**Bulletin No.....:** TS-C105

**Bulletin Name.....:** Relocating Transmission Oil Dipstick

**Vehicle Model.....:** TS 35

**Subject:** For ease of access to oil dipstick, the rod has been re-routed.

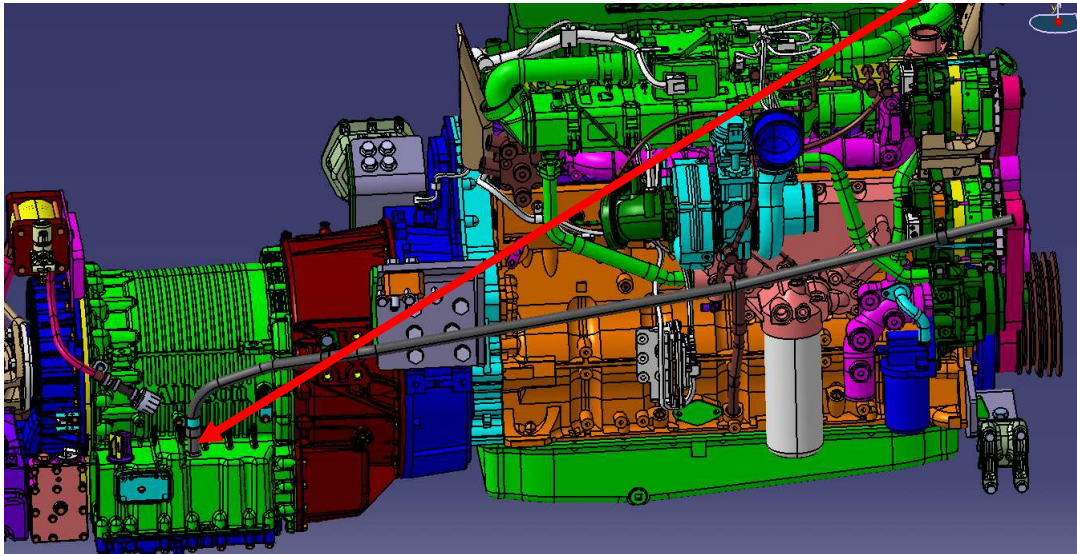
2. First , in the place of the removed level rod, level rod pipe must be mounted. (RP196120Y)

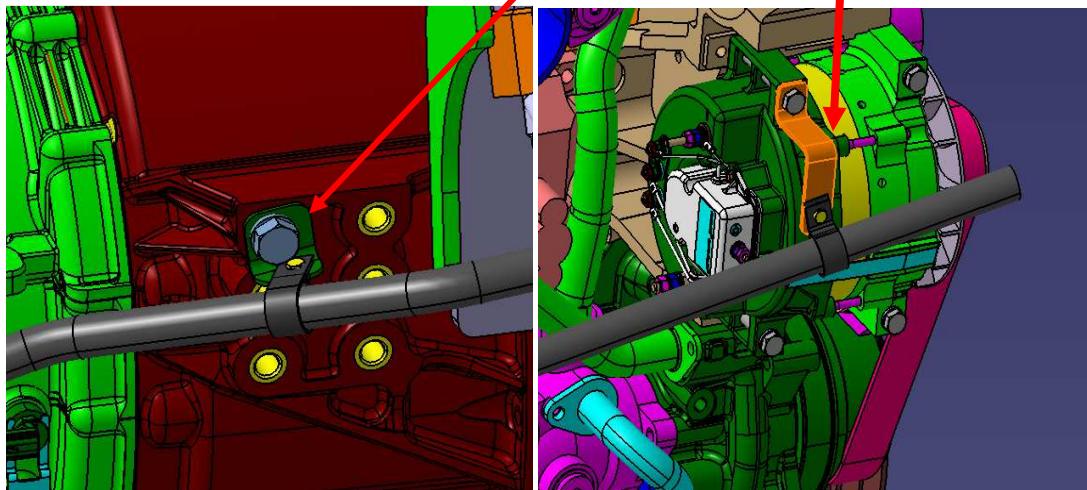
3. Then, the clamps must be fixed to the connection points on the engine and the clamp should be installed on the alternator by the RP109140 and RP109139 bracket.

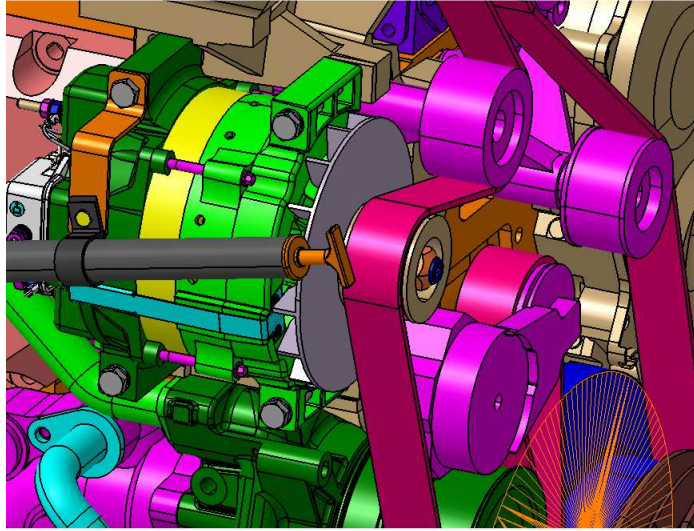
4. The level rod is placed inside the pipe.
